**ADDENDUM NO. 3**

**PROJECT NO. DGS C-0503-0026 PHASE 001**

**PROJECT TITLE - North Central STU - HVAC Upgrades**

**DRAWING CHANGES – ALL CONTRACTS**

BASEMENT PLANS - GREEN BUILDING  
PIPING

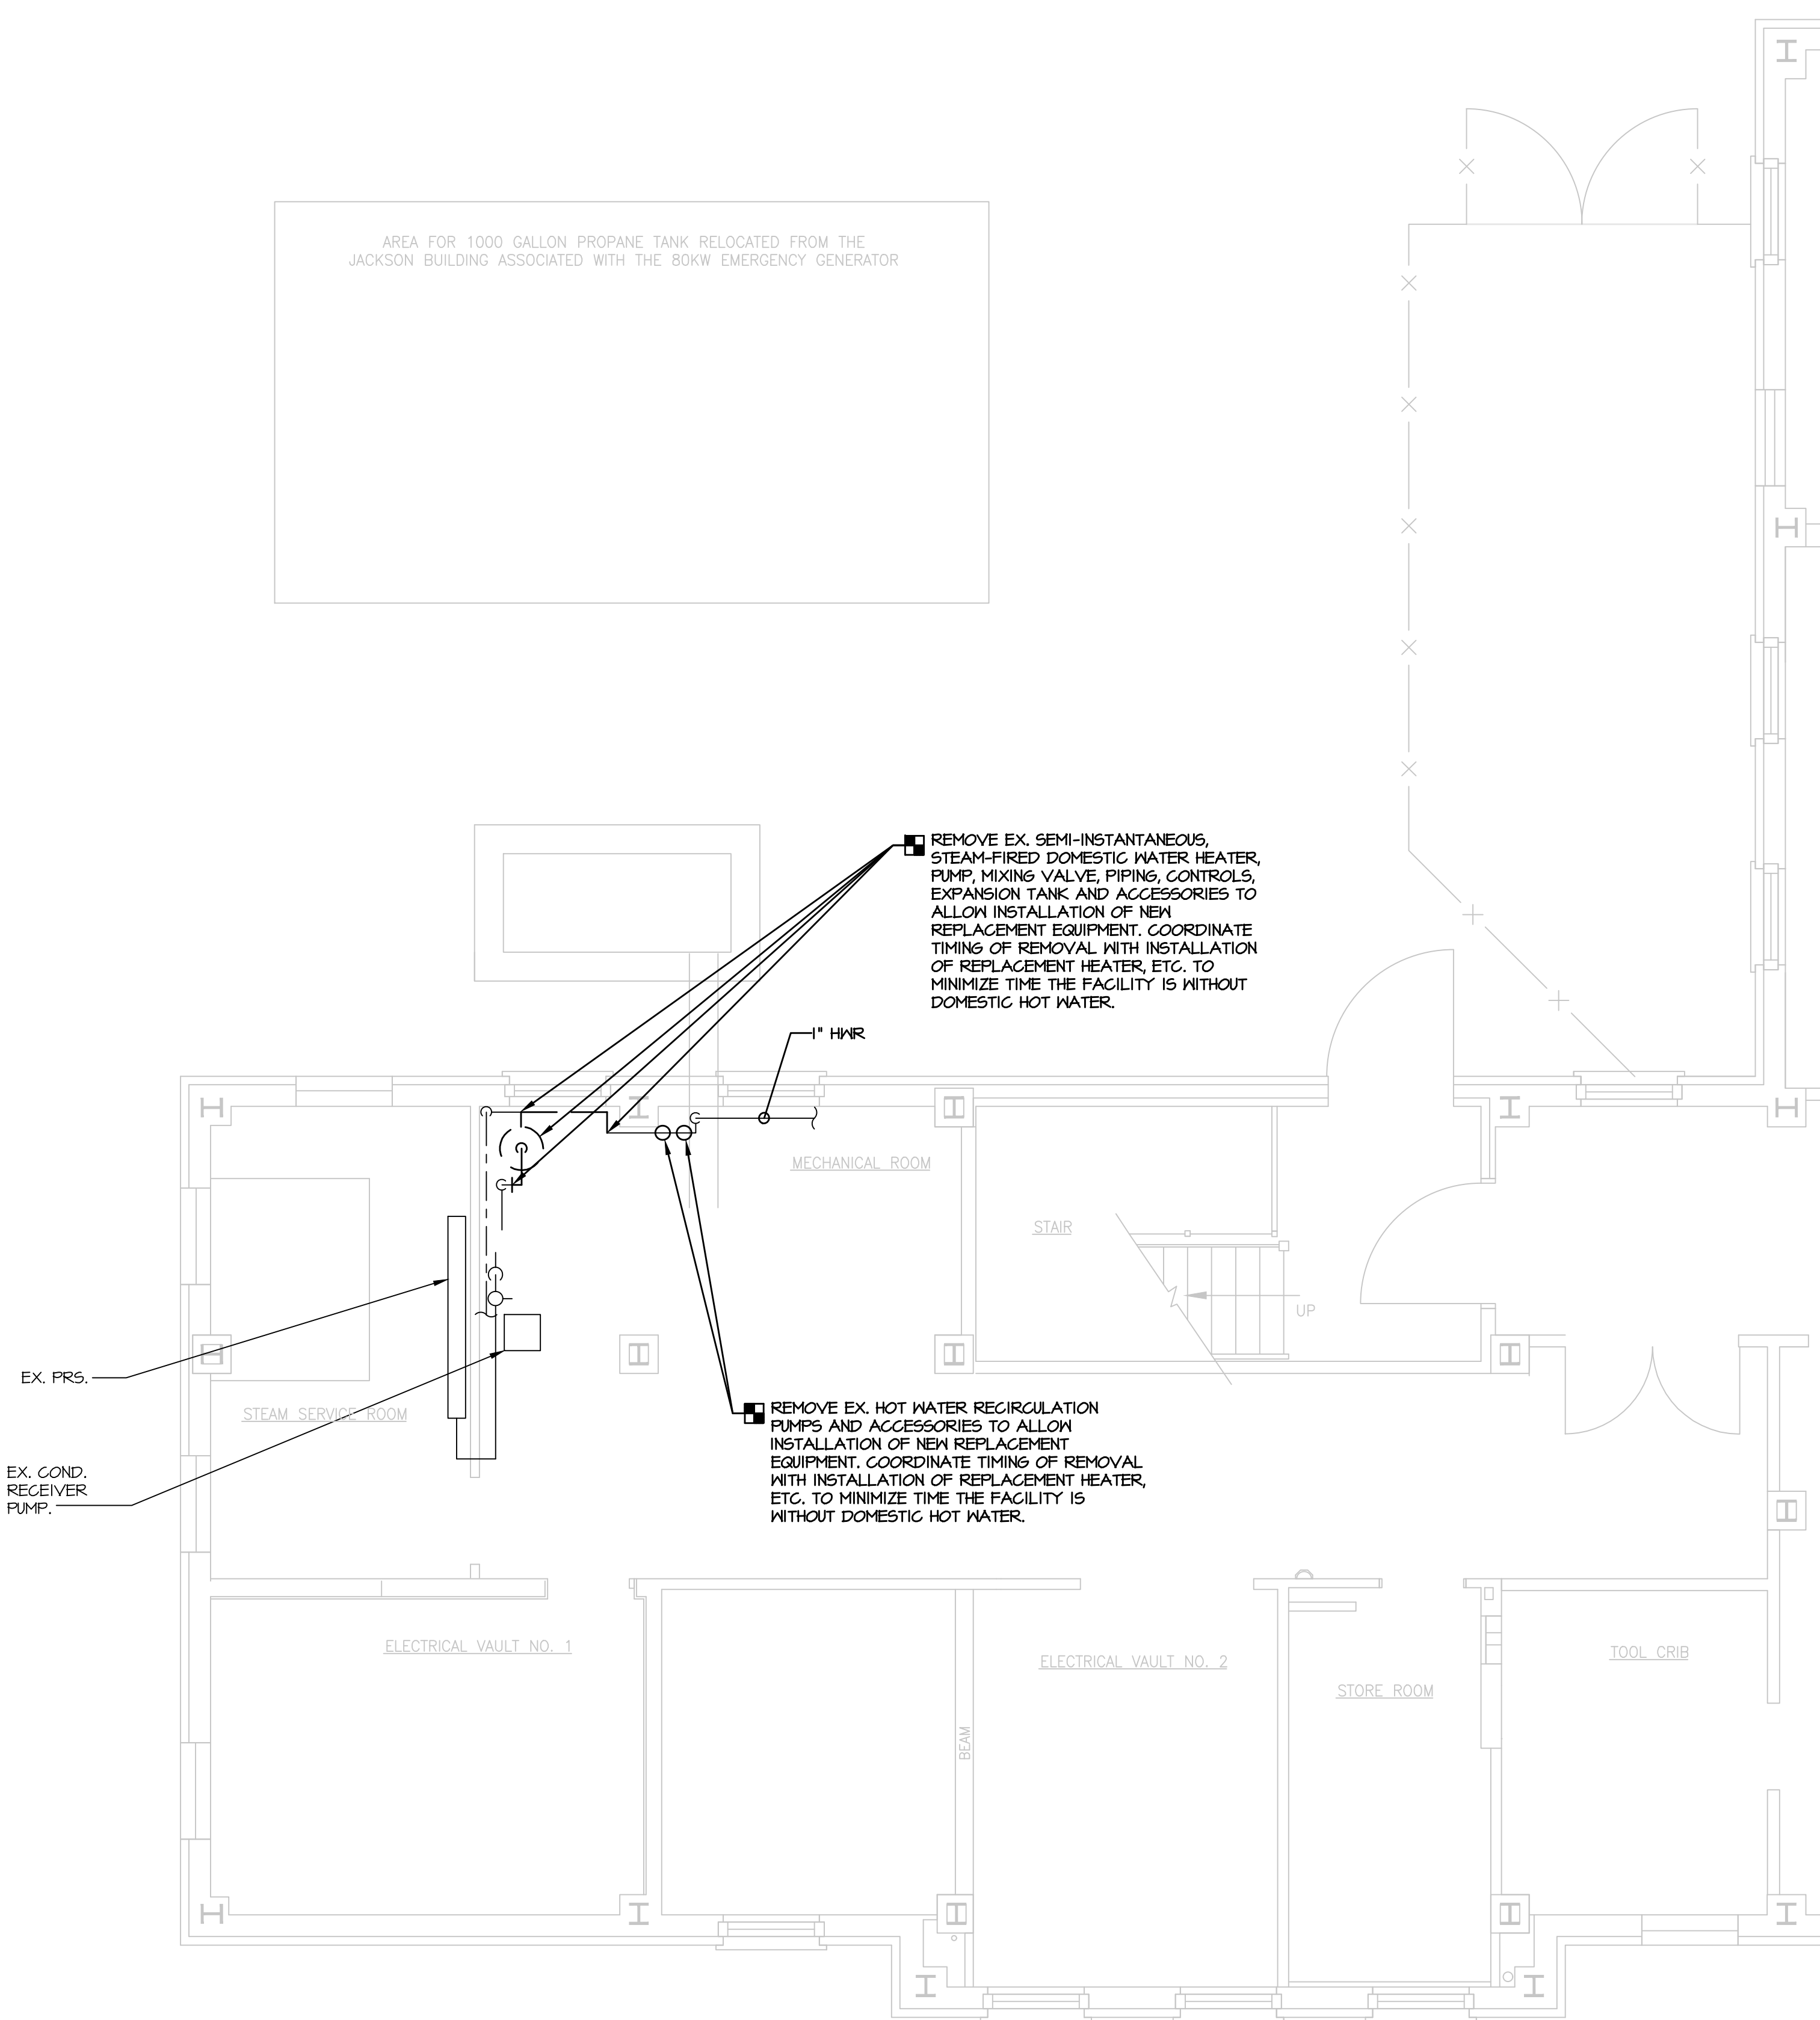
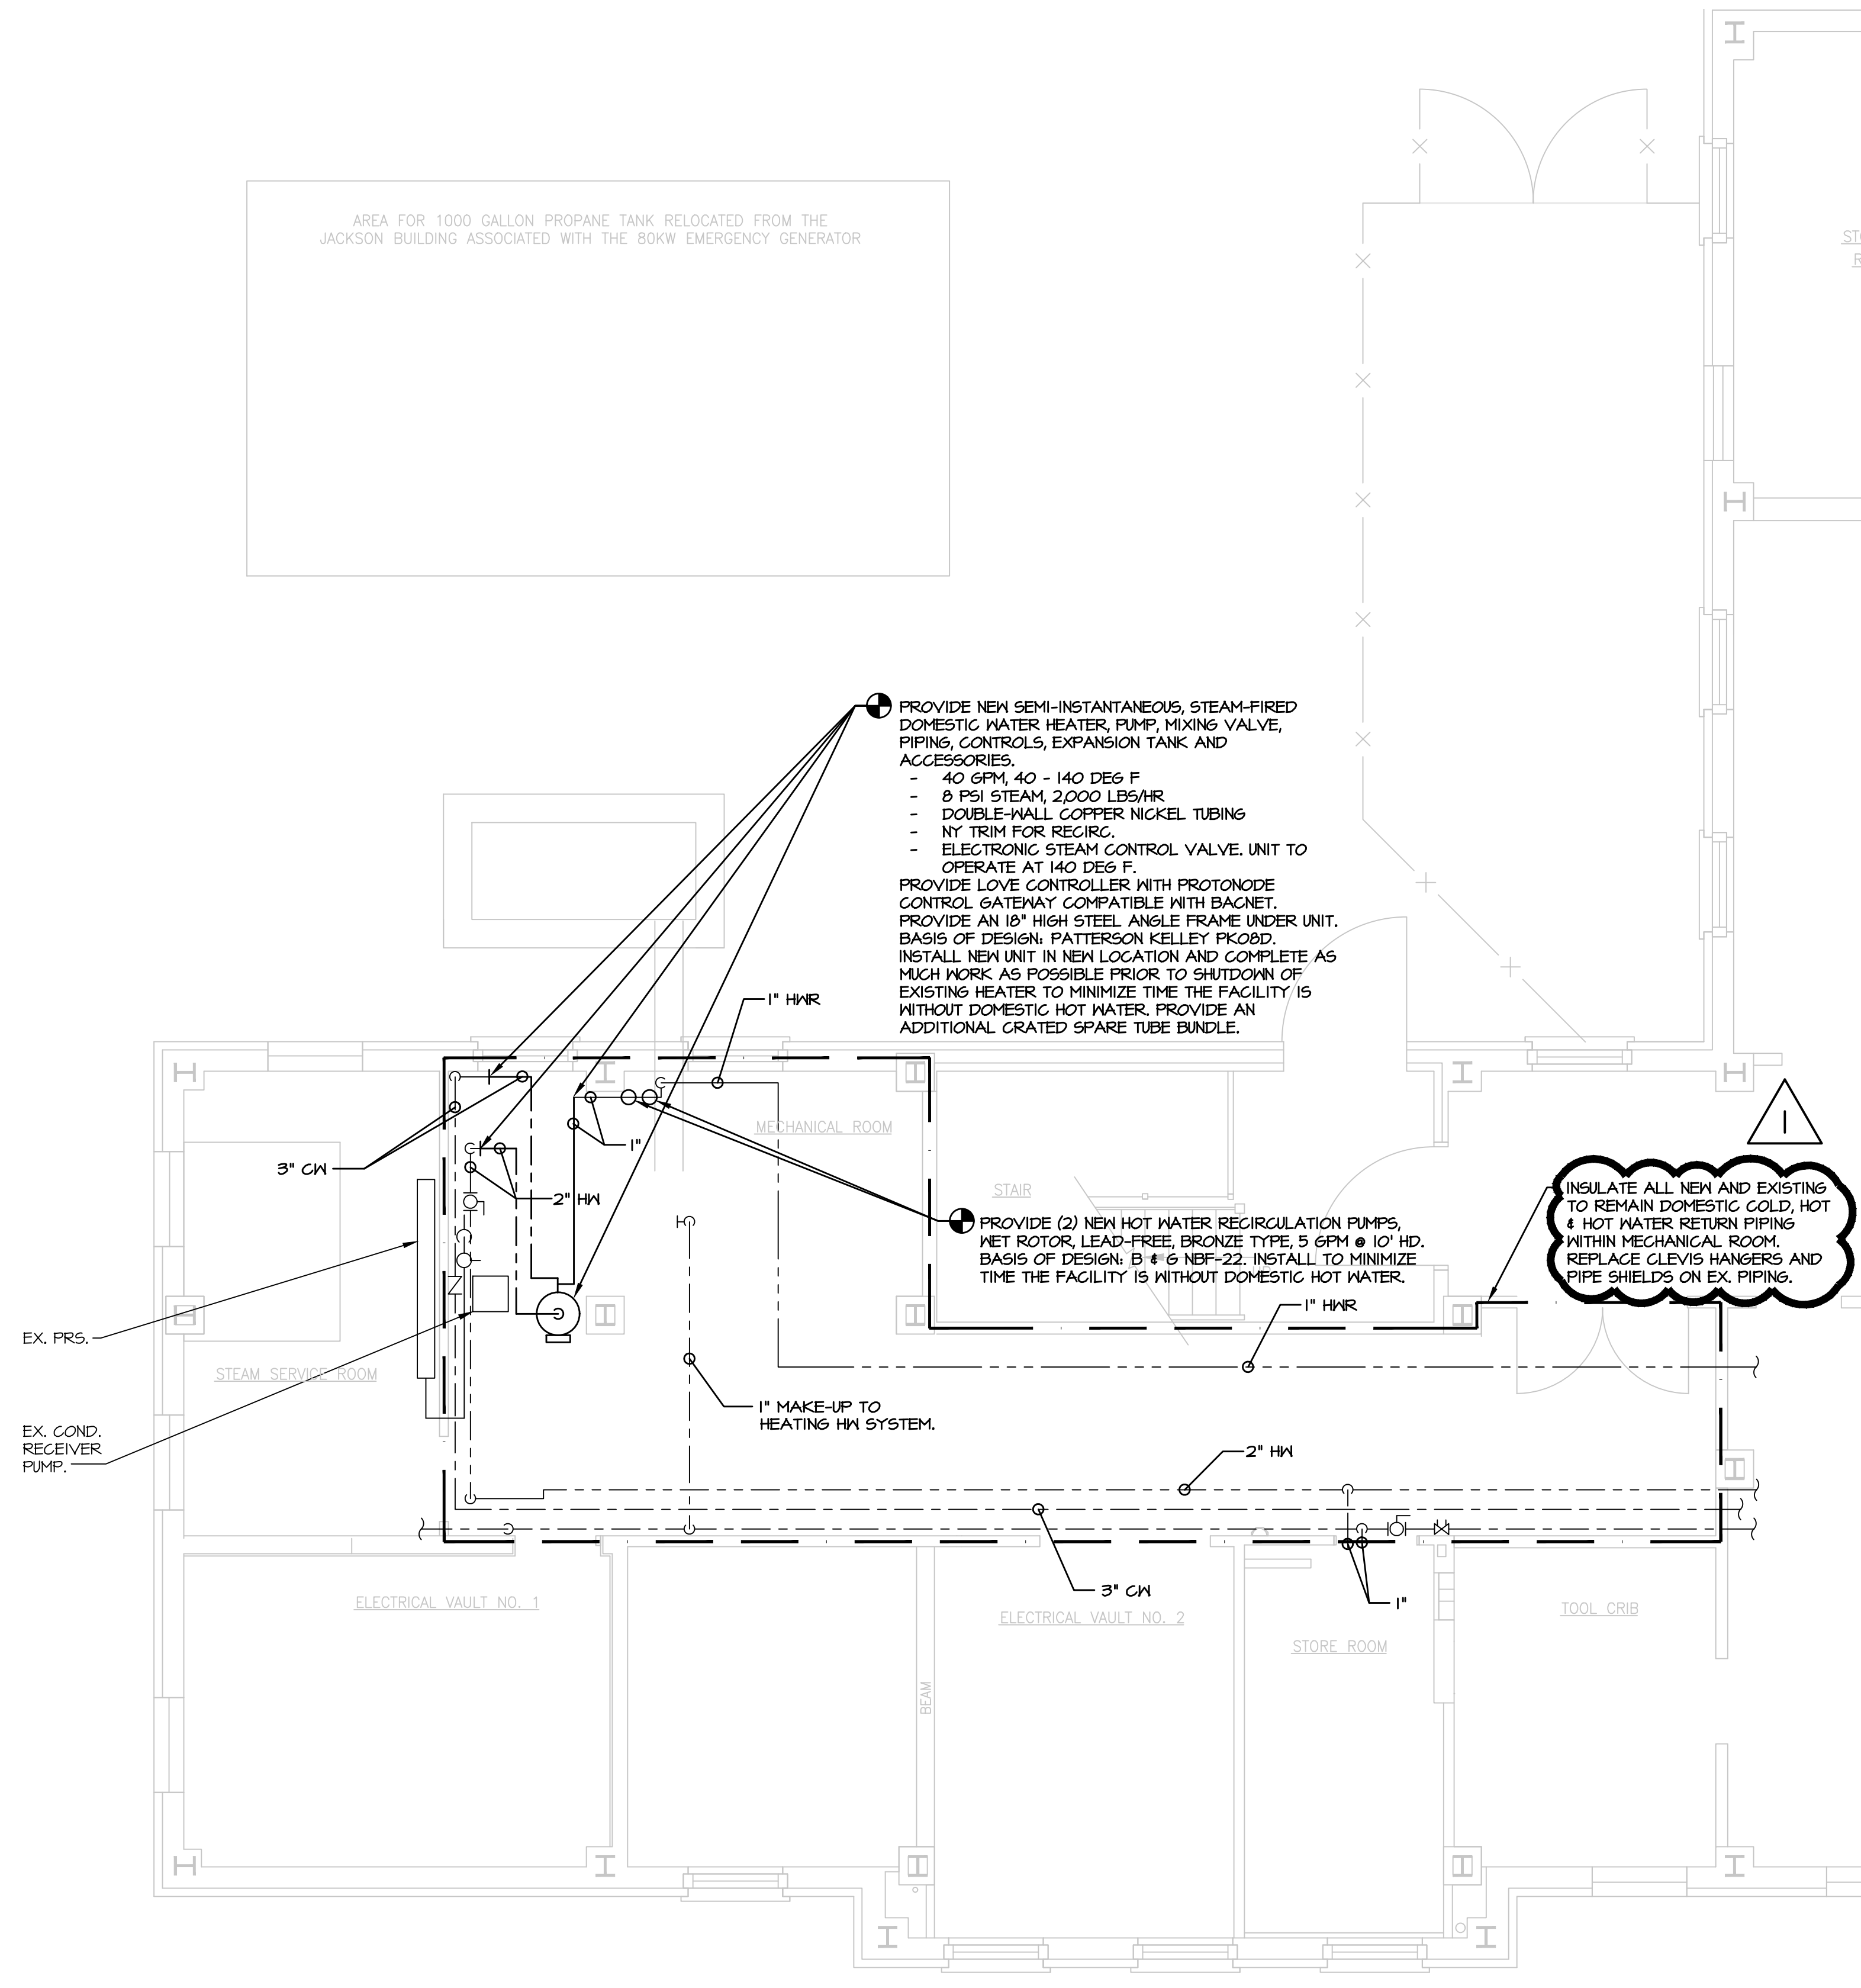
Item 4 - Drawing H-5 Green Building Basement Plan Piping - Revised note pertaining to insulation of new and existing piping and note for exterior pipe covers.

- SCHEDULE STEAM SHUTDOWNS WITH THE CLIENT AGENCY TO AVOID LOSS OF HEAT AND SERVICES TO THE BUILDING DURING CONSTRUCTION.
- INSTALL PIPE COVER ON ALL EXTERIOR REFRIGERANT PIPING. REFER TO DETAIL 11A-11.

BASEMENT PLAN - GREEN BUILDING  
PLUMBING

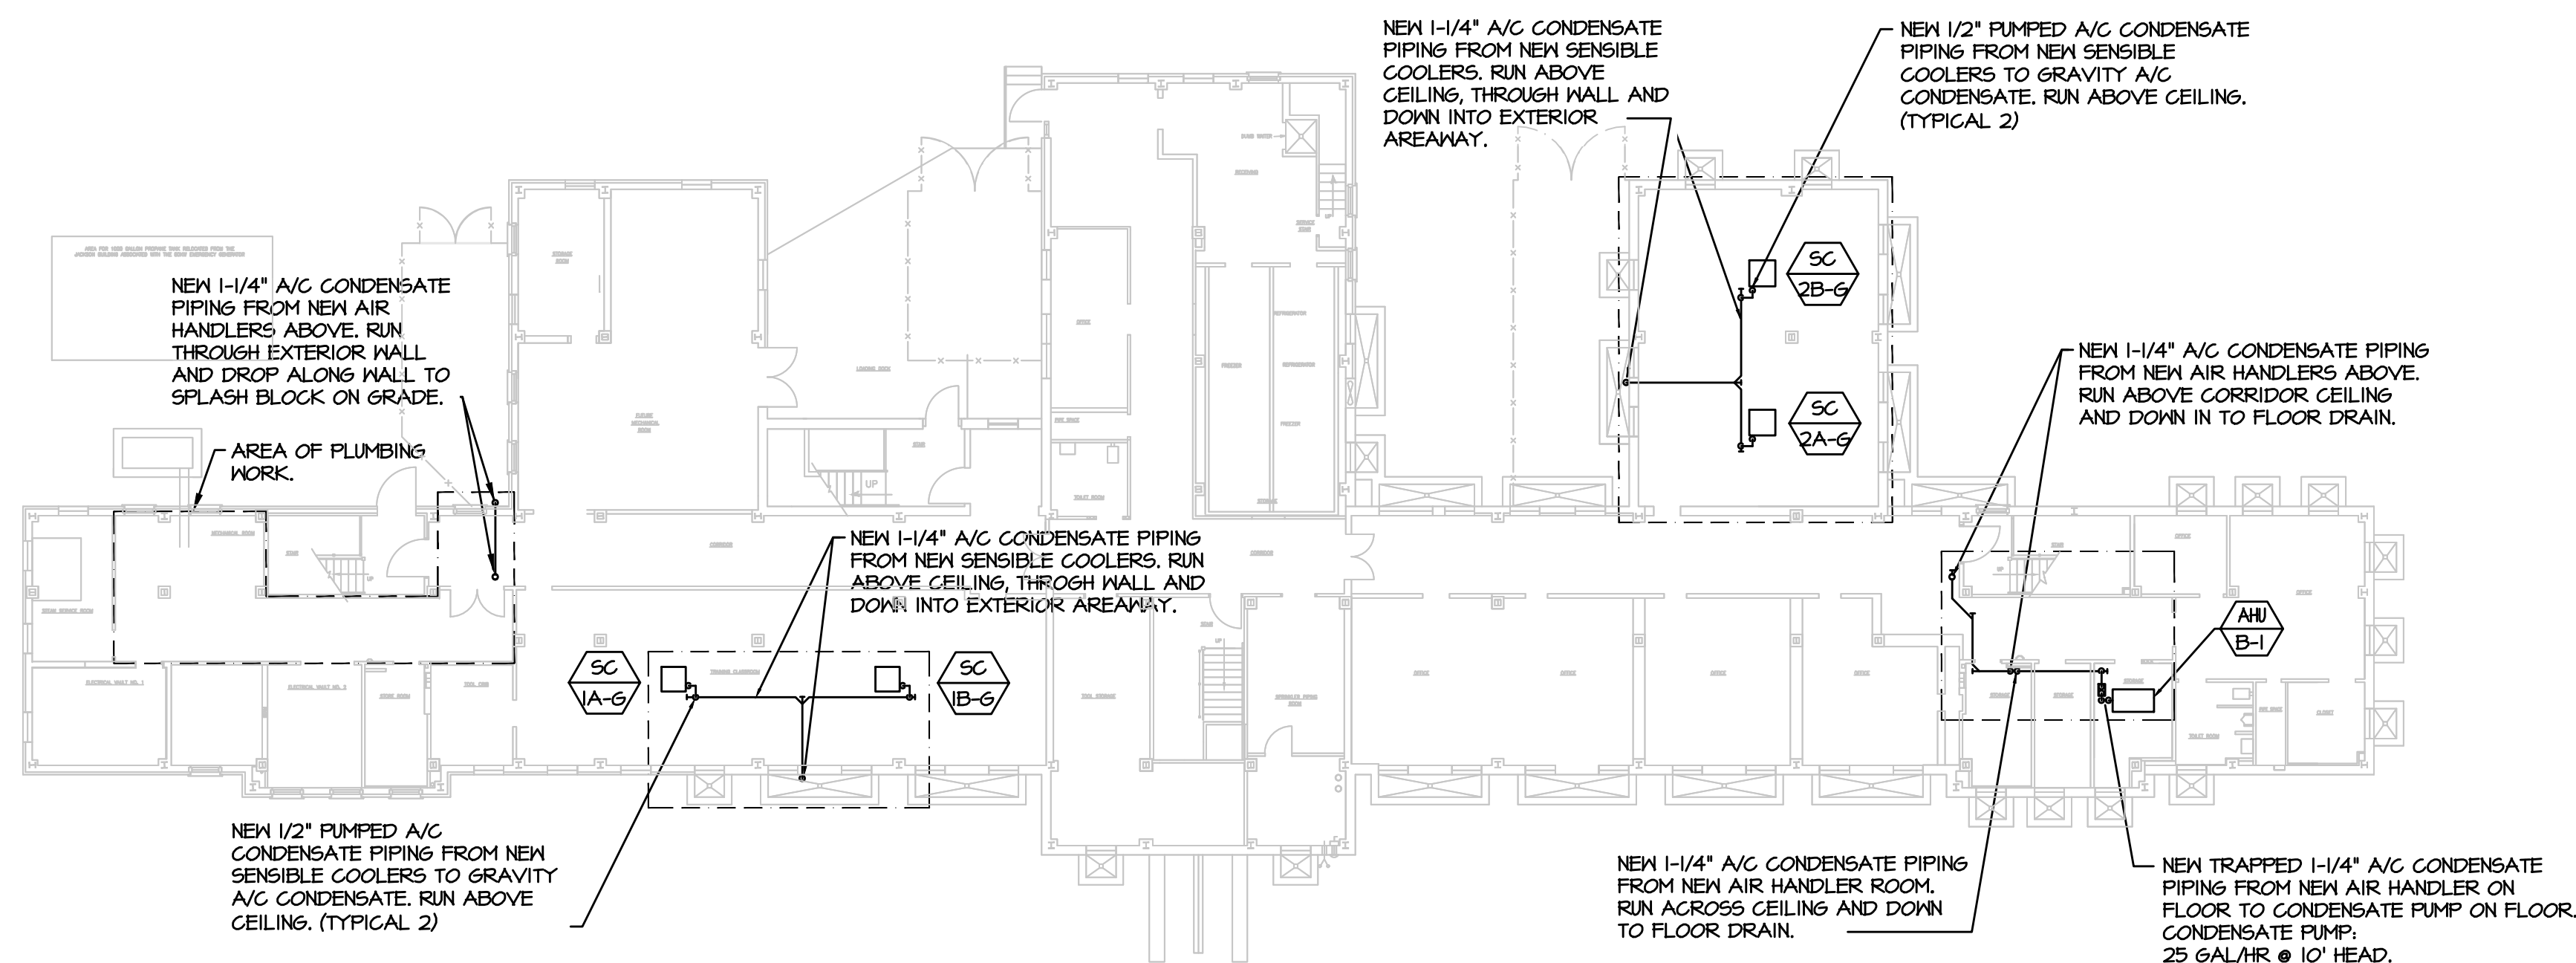
Item 3 - Drawing P-2 Green Building Basement Plan Plumbing - Revised note pertaining to insulation of new and existing piping.
